Kenai Peninsula Borough

Meeting Agenda Plat Committee

Monday, November 17, 2025

KPB 2025-113 As-Built

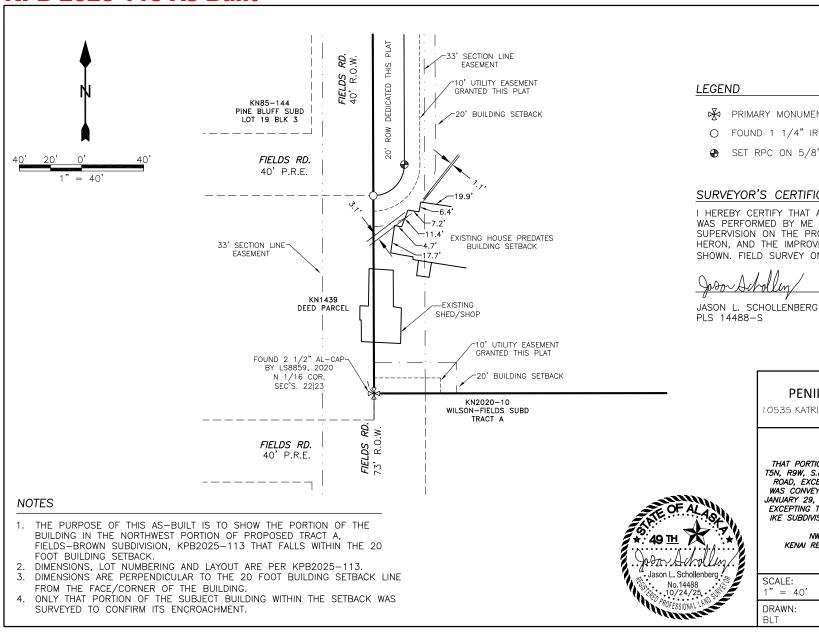
The dedication of Fields Rd on the west required a 20' building setback pursuant to 20.30.240. As shown in the As-Built Survey in the packet there is an existing house that encroaches 1.1 and 3.1 feet into the newly-created 20' building setback line. Per 20.10.110.A. "Unless otherwise regulated by city zoning ordinances of properties within its boundaries, any person desiring to construct, or cause, an encroachment within a building setback shall apply for a building setback encroachment permit to the planning department." Since the 20' setback line is being created by this plat and the encroaching structure therefore preexists the setback line, the appropriate remedy is to request an exception to KPB code 20.30.240 for the structure, which the surveyor and applicant have done.

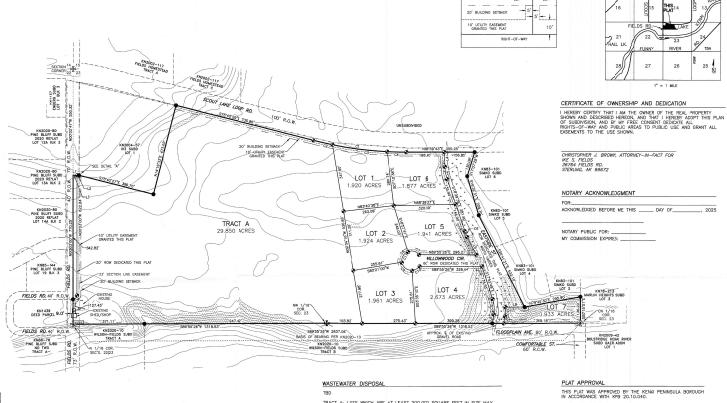
To help reduce driveway entrance / exit traffic along Scout Lake Loop Road, **Staff recommends** a plat note be added stating Lot 6 should have interior access only,

There also appears to be structures shown on the drawing in the southwest crossing the property line into the adjacent land. The purchaser of Tract A has spoken to staff about the issue and the current owner of the adjacent land is going to provide an easement permitting the structures to remain as located and have a buffer area around

them for maintenance. He plans to purchase the adjacent land and combine it with Tract A at that time. **Staff recommends** the easement for the structures be filed prior to finalization of the plat and be shown and noted on the drawing.

KPB GIS Imagery KWF Wetlands Assessment layer shows a riverine running north to south on the easterly boundary of the subdivision. The riverine has been added to the preliminary plat as identified in the legend.

KPB GIS Imagery contours shows steep slopes exceeding 20% located primarily on the south and east. Contours at 5-foot intervals have been included on the preliminary plat with slopes greater than 20% represented in the legend. **Staff recommends** it is the surveyor's discretion to remove the contours from the final plat per KPB 20.60.010.

A soils report will be required and an engineer will sign the final plat for Lots 1-7 as the new lots are less than 200,000 sq ft. A soils report will not be required for Tract A as the lot is greater than 200,000 sq ft. **Staff recommends** the Wastewater Disposal Note be modified to the correct KPB note after soils report has been completed.

Gateway Subdivision 2025 Addition Preliminary Plat

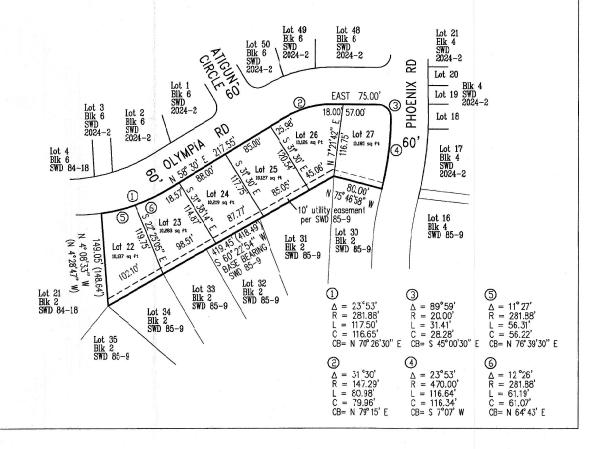
The City of Seward is responsible for floodplain management within their jurisdiction and has indicated that the subject parcel is not located within a FEMA-mapped flood zone. **Staff recommends** plat note number four be modified to state that the City of Seward should be contacted for development information and regulation, and that the FEMA panel number be modified to 02122C4539D.

Gateway Subdivision (SW 84-18) granted a 10-foot pedestrian and utility easement along portions of former Tract C. Gateway Subdivision Add. No 1 (SW 85-9) carried forward this easement and granted the easement along the southern boundary. **Staff recommends** the surveyor modify the label on the southern boundary and include a depiction and label of the easement along the west boundary of proposed Lot 22.

o Correct typo in plat note number three: "plans for wastewater disposal that meet..."
